Docket # 2025-07
201 Brookline Avenue
Boston, Massachusetts

FIRE PREVENTION REGULATIONS APPEALS BOARD DECISION

Whether the Board should affirm, reverse or modify¹ the Boston Fire Department's determination that Laboratory Suite 13-1 requires a proper separation in accordance with NFPA 45 (2019 Edition) Table 5.1.1, as adopted by 527 CMR 26.1.1?

Figure 1 - Level 13 Non-Laboratory Egress Overview

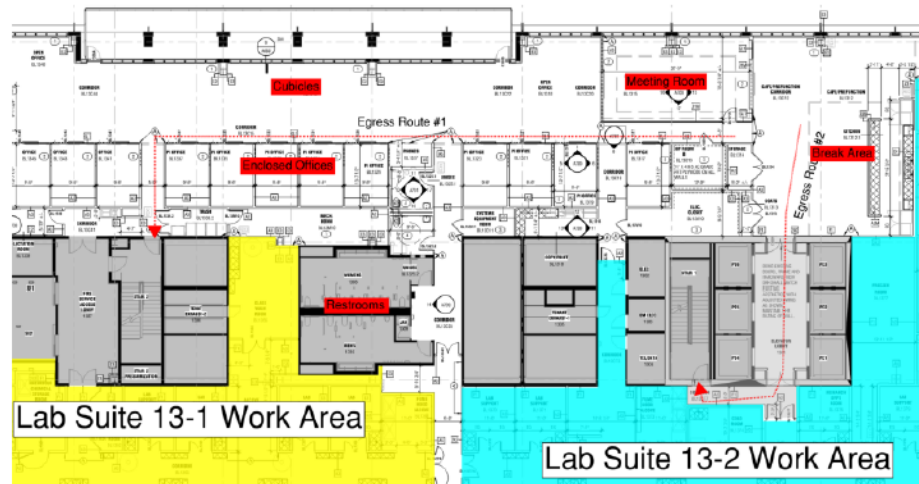
2. The Board finds that there are two laboratory suite spaces on the 13th floor of BCH at 201 Brookline Ave, Boston, identified as Laboratory Suite 13-1 and Laboratory Suite 13-2 (see figure below). The Board finds that the plan for Laboratory Suite 13-1 was denied for

lack of fire rated separations between spaces to be used for laboratory purposes and ancillary spaces such as conference rooms, break areas and administrative offices.

5. The Board finds that Laboratory Suite 13-2 was approved by the Boston Fire Department based upon the existence of 2 hour fire barrier separations (figure above) but did not hear any substantial testimony as to why Laboratory Suite 13-1 was not constructed in similar manner to include fire rated separations.

6. The Board finds that the meeting/break room exceeds the intent of the code and does not consider the space to be an accessory. To align Laboratory Suite 13-1 with the safety requirements of NFPA 45 (2019 Edition), Table 501.1 as adopted by 527 CMR 1.00, 26.1.1, the Appellant may wish to consider modifying the space to eliminate the kitchenette.

Based upon the evidence presented to the Board and for the reasons stated herein, the Board hereby **upholds** the determination (denial) of the Boston Fire Department regarding 201 Brookline Ave, Boston.
